No.Ft.48-5297/2021
H.P. Forest Department.

Subject: Proposal for seeking prior approval of the Central Government under Forest (Conservation) Act, 1980 for non-forestry use of 211.8427 ha. of forest land for construction of 500 MW Dugar Hyrdo Electric Project in favour of NHPC Ltd. under Pangri Forest Division and Chamba District of Himachal Pradesh (Online Proposal No. FP/HP/HYD/123533/2021).

Please refer to your office letter. No. 8-15/2022-FC dated 05-09-2023 on the subject cited above.

Figure 10.10: Layout of Muck Disposal area

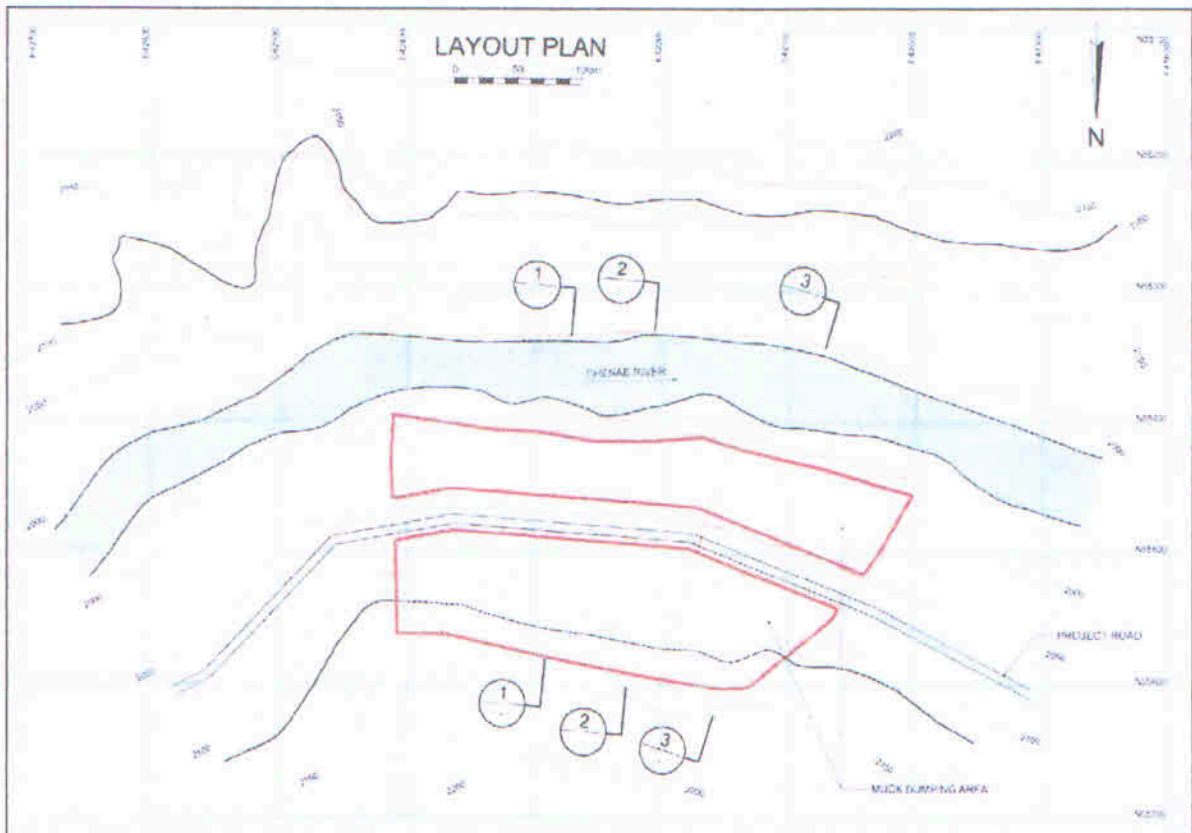
vii. The Muck dumping (8.5797 ha) and the job facility area (7 ha) can be taken on non-forest land. The justification for proposing the same on Forest land may be submitted.

Keeping the above requirement, one muck disposal site has been identified downstream of the proposed powerhouse with a total area of 8.58 ha and capacity has been worked as 8,75,000 cum which is much more than the total quantity of muck to be disposed of (refer to **Figure 10.10**).

For stacking of dumped material, concrete reinforced retaining walls are proposed to be built before dumping any material onto the sites (refer to **Figure 10.10**). In addition, leveling would
